MANDATORY SERVICE BULLETIN Z 50/40a-Rev.1, Z 50M/12a-Rev.1

Supersedes Mandatory Service Bulletin Z 50/40a, Z 50M/12a, dated
May 26, 1997

1. DATE: December 1, 1997
 2. MODELS AFFECTED: All Z 50L, Z 50LA, Z 50LS, Z 50LX, Z 50LE
and Z 50M aircraft.
 3. SUBJECT: Sporadically occurred damage of the stabilizer
rear attachment fitting.

ENCLOSURE

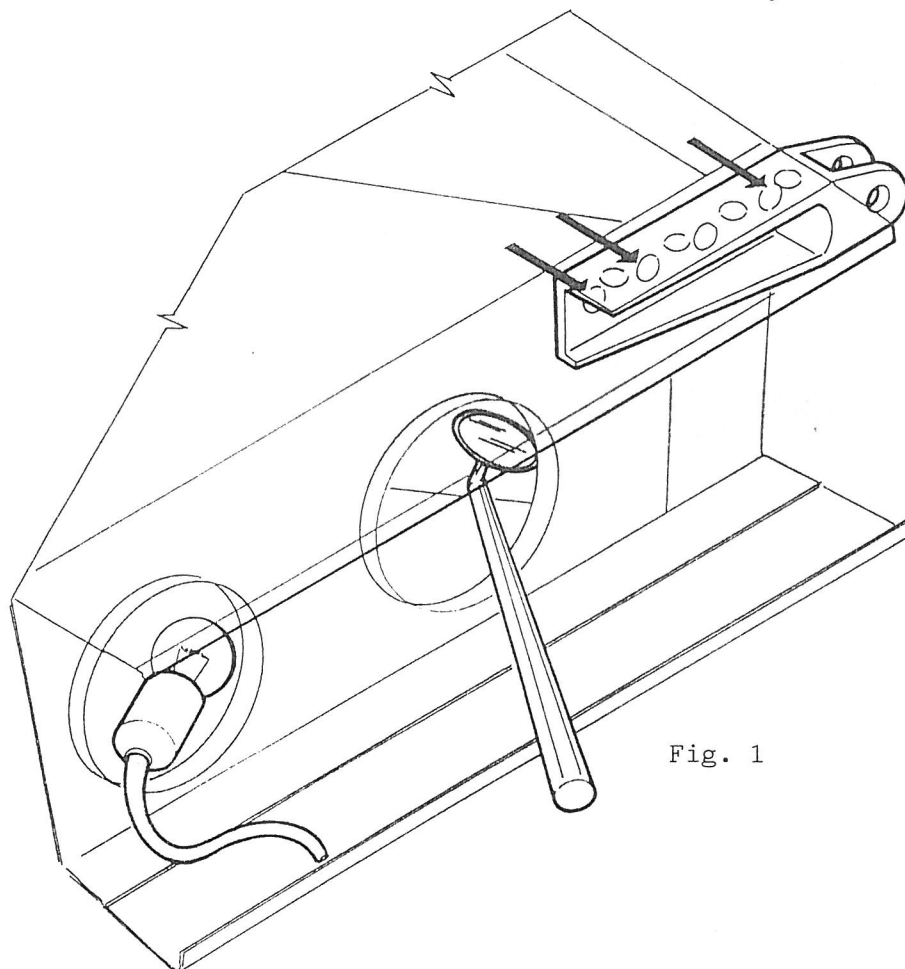
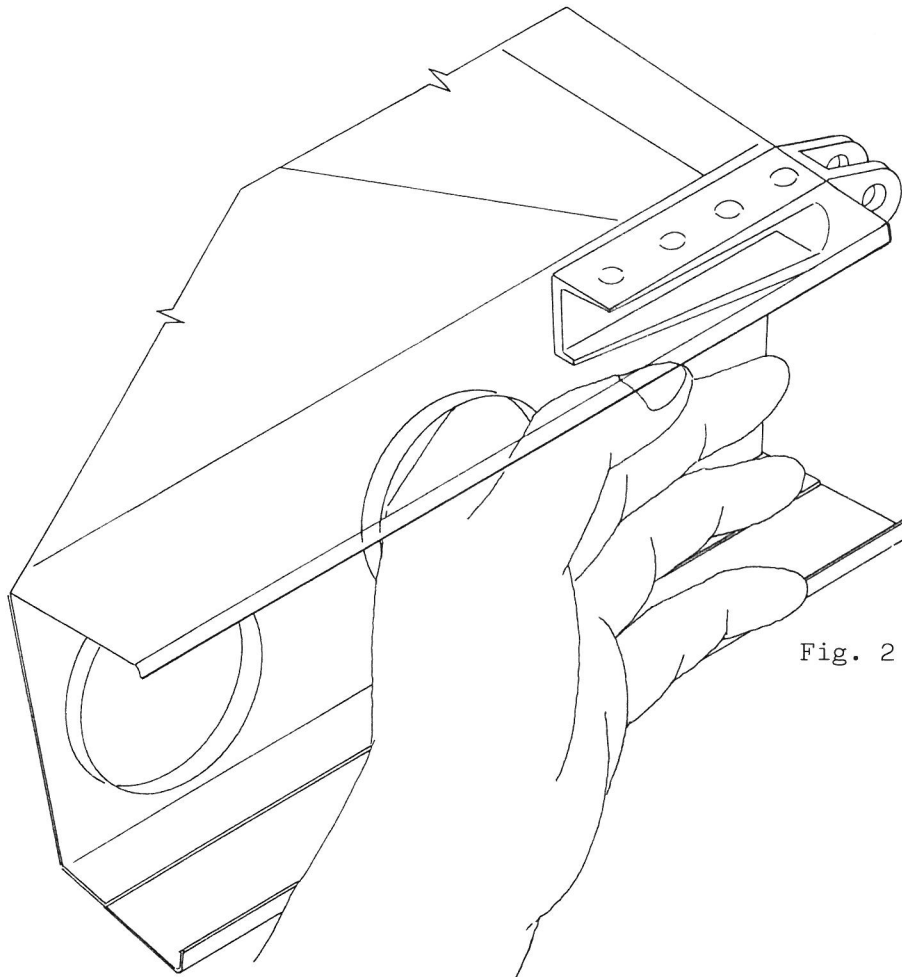
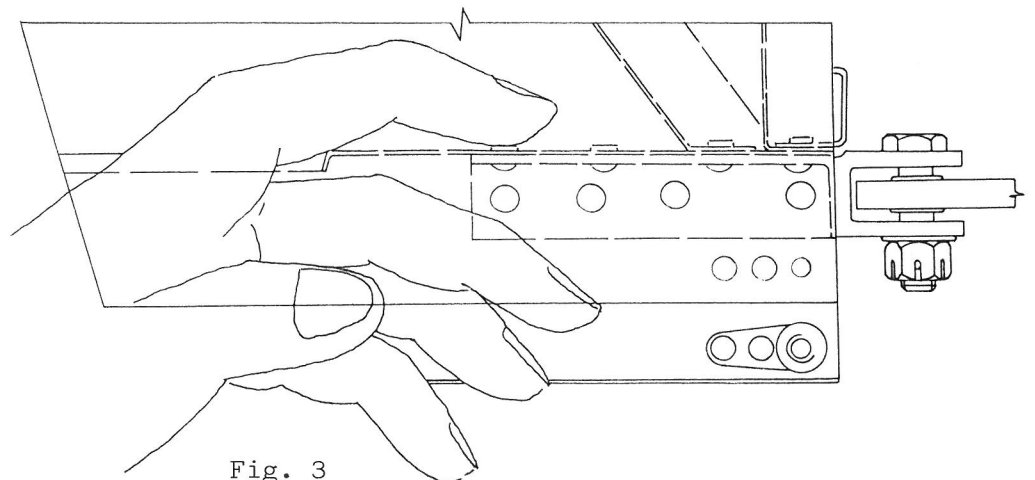
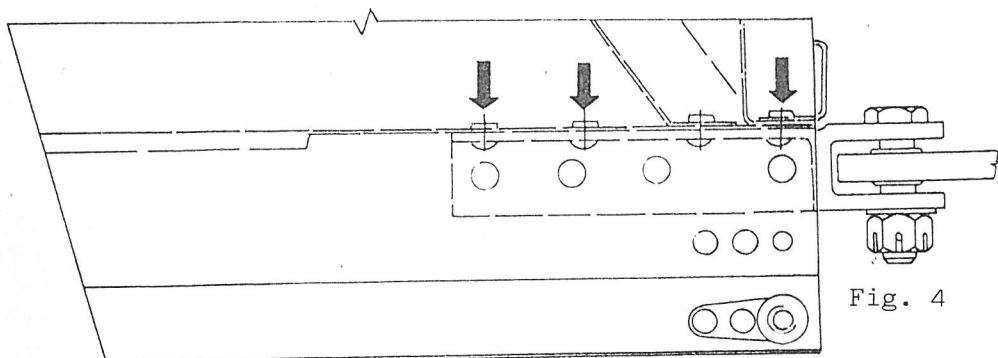
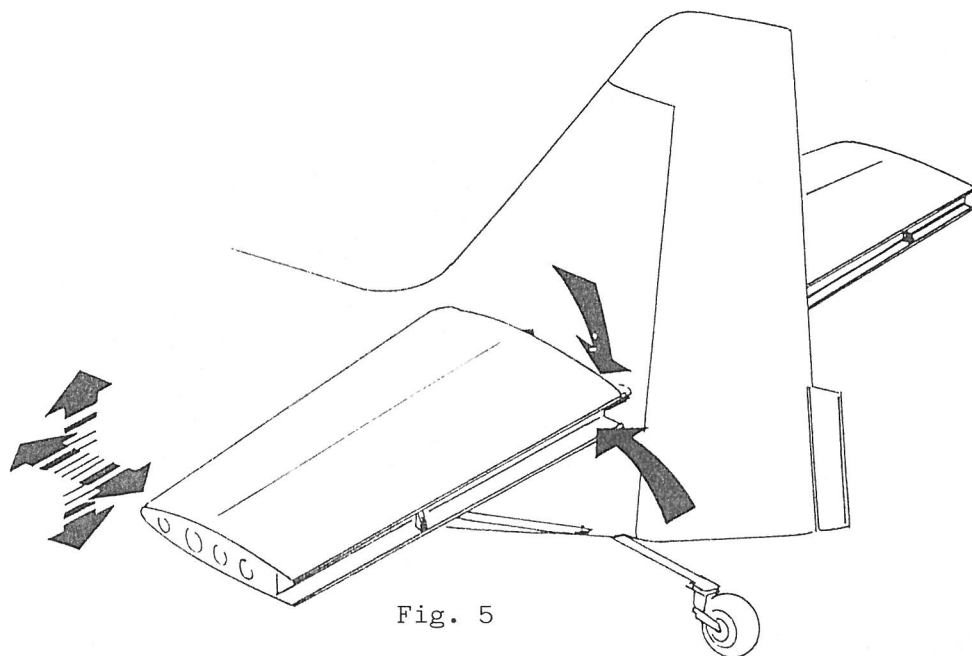
Check the riveted joint at L.H. and R.H. stabilizer rear attachment fittings both visually and by touch from the spar rear side and through the hole in the spar web from inner side by touch and using the mirror while loading the stabilizer on the tip rib alternately upwards - downwards and forwards-backwards. The first rivet of the fitting should be checked from the web inner side through the slot disclosed after removal of the fairing. The checking procedure is shown in the enclosure, see Fig. 1 up to 5. Either loosened or cut off rivets are inadmissible. If the riveted joint is detected, accomplish working procedure described in the Service Instruction No. 4.

1. Remove fairings between the stabilizer and the tail fin.
2. Disconnect cables of the trim tab control from L.H. elevator.
3. Remove L.H. and R.H. elevator.

1. Reinstall L.H. and R.H. elevator. Lock the castellated nuts with cotter pins.
2. Connect cables of the trim tab control at L.H. elevator.
3. Reinstall fairings between the stabilizer and the tail fin.
